**SUBJECT: AOS REQUEST TO AMEND CERTIFICATE OF COMPLIANCE 9316**

USNRC Reference: EPID L-2021-LLA-0071, Docket No. 71-9316

# **Radioactive Material Transport Packaging System Safety Analysis Report**

**for Model AOS-025, AOS-050, and AOS-100 Transport Packages**

**Figure 7-4. Typical Vacuum Drying System Setup and Equipment**

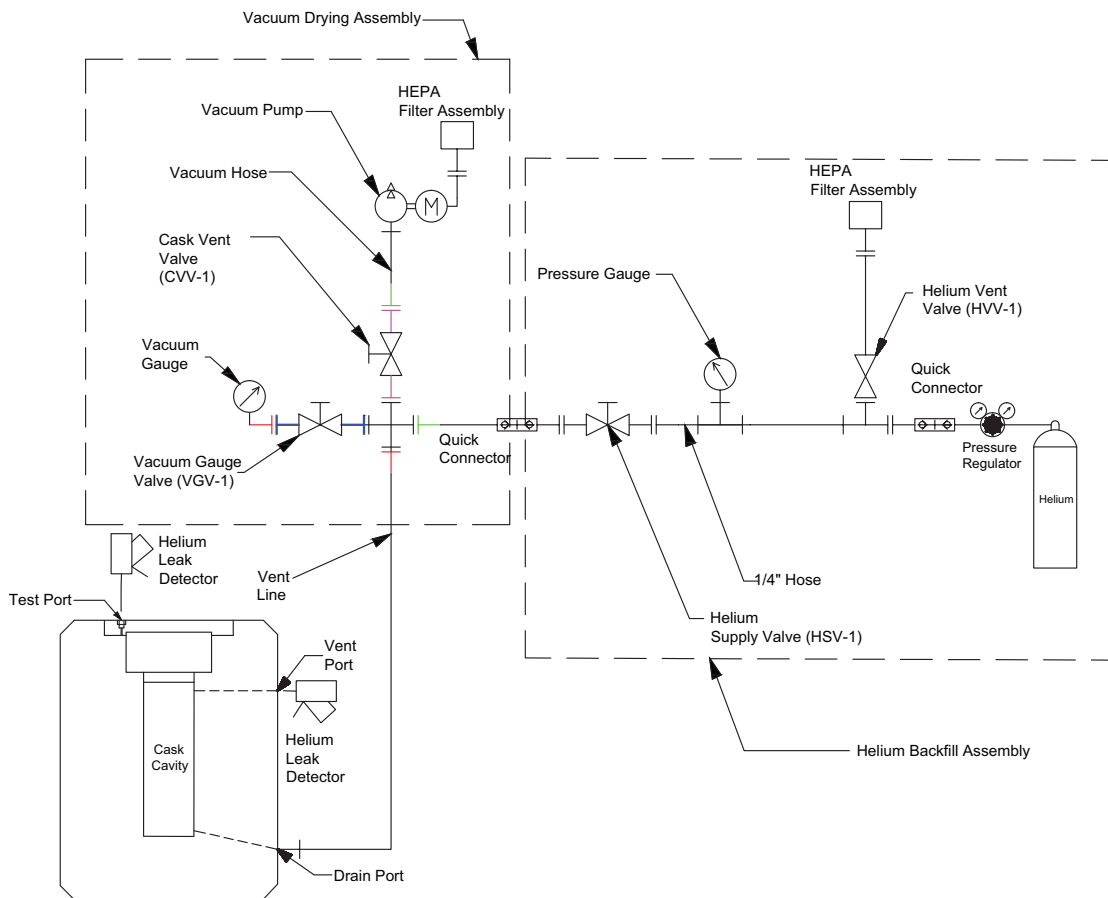
- h. [Figure 7-4](#) illustrates a typical vacuum drying system and its basic components. These components include a vacuum pump, pressure gauge, connectors, and valves.

Figure 7-4 illustrates a typical Leak testing setup (vacuum drying system and its basic components) that can be used for all AOS Radioactive Material Transport Packaging System models (Models AOS-025A, AOS-050A, AOS-100A, AOS-100B, and AOS-100A-S).
